THE GENERIC
SAFETY EVALUATION REPORT RELATING TO
THE MARK III CONTAINMENT HYDROGEN CONTROL

By letter dated August 24, 1987, you committed to provide, within 6 months of SER issuance, the final analysis of the Clinton Power Station combustible gas control system required by 10 CFR 50.44. Accordingly, you are requested to provide the final analysis by March 1, 1991, addressing each of the key elements identified in the staff's SER, Section 8.0.

Figure B.1 Operator Actions to Control Hydrogen

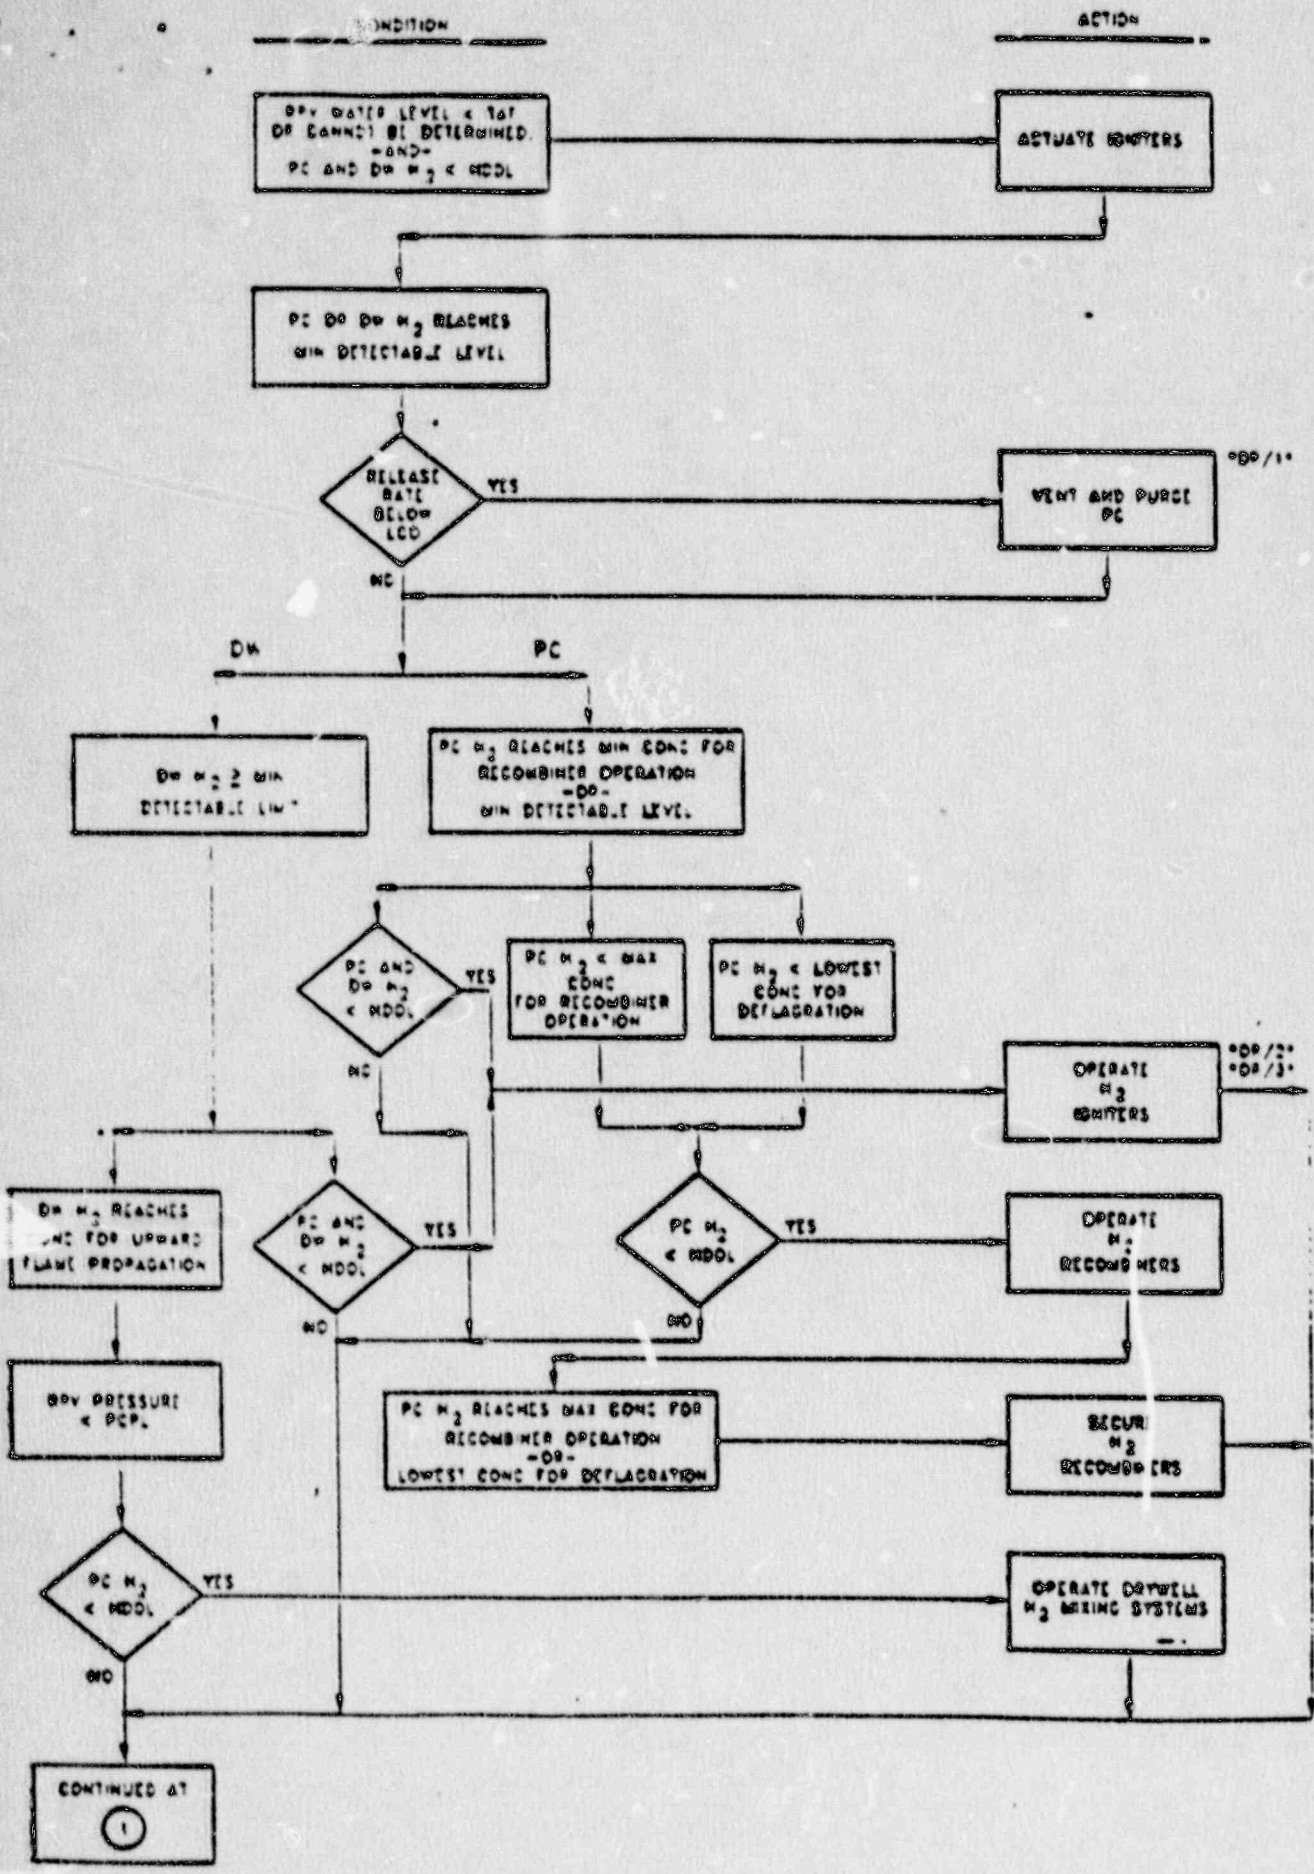
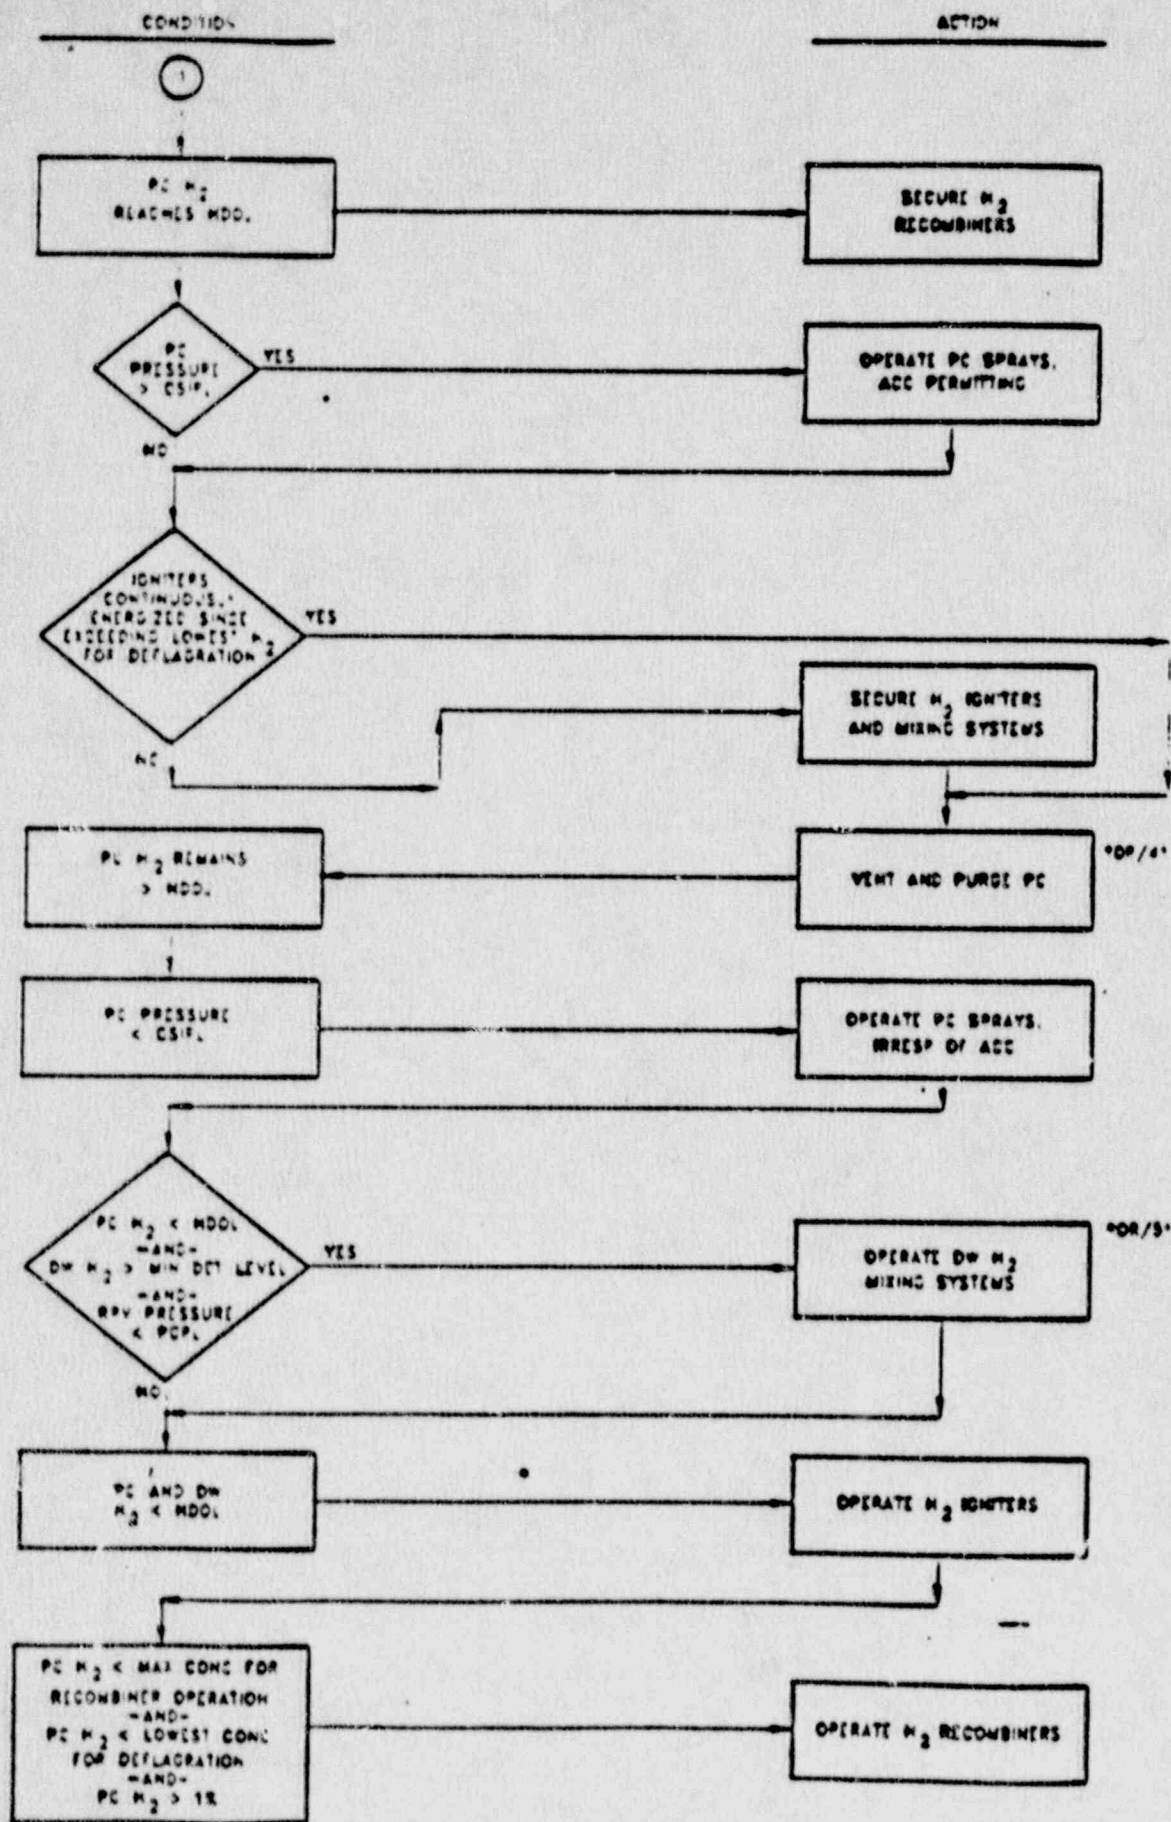
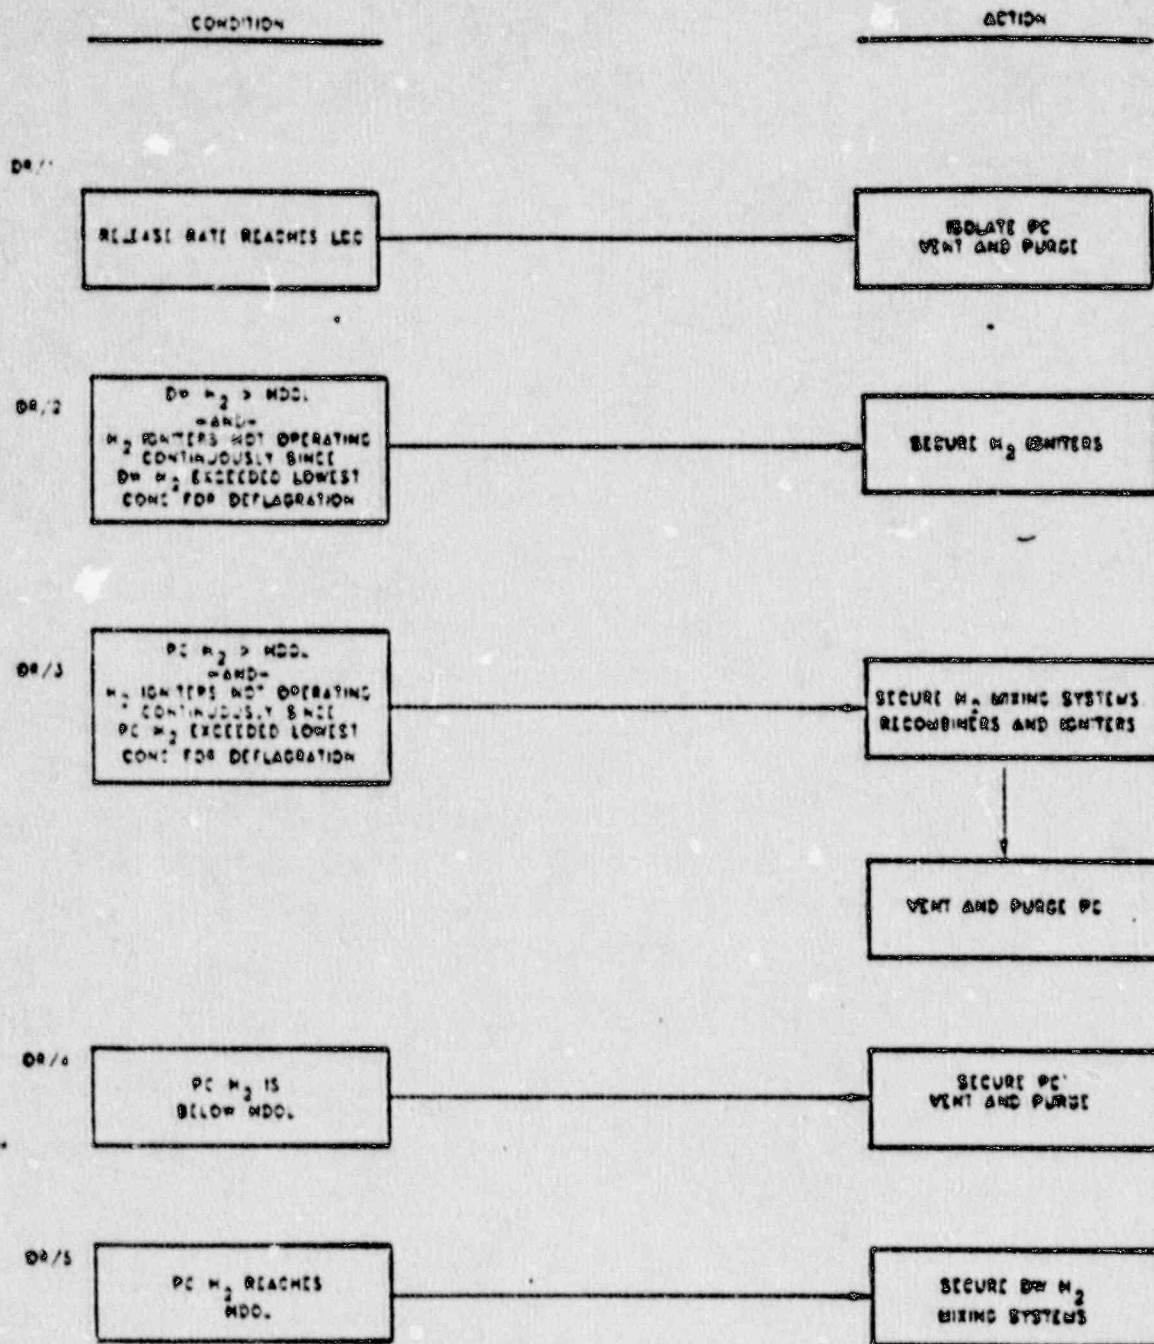
The staff believes some of HCOG concerns are valid. In addition, HCOG had modified its procedures to assure that the HIS would remain operational above the HDOL if it can be determined that the igniters have been continuously operating. The addition of an independent power supply to the MIS would further enhance the reliability of the system. Consequently, the added reliability would reduce the potential for containment venting to control hydrogen inside containment. Therefore, the staff agrees with HCOG that the inclusion of the drywell mixing system would not provide significant benefits (in delaying venting) as compared to its disadvantages.

Overall, the staff finds the proposed (Revision 3) Mark III containment EPGs are based on sound technical judgment, and are acceptable. Accordingly, each Mark III licensee should address its combustible gas control emergency procedure in the plant specific final analysis.
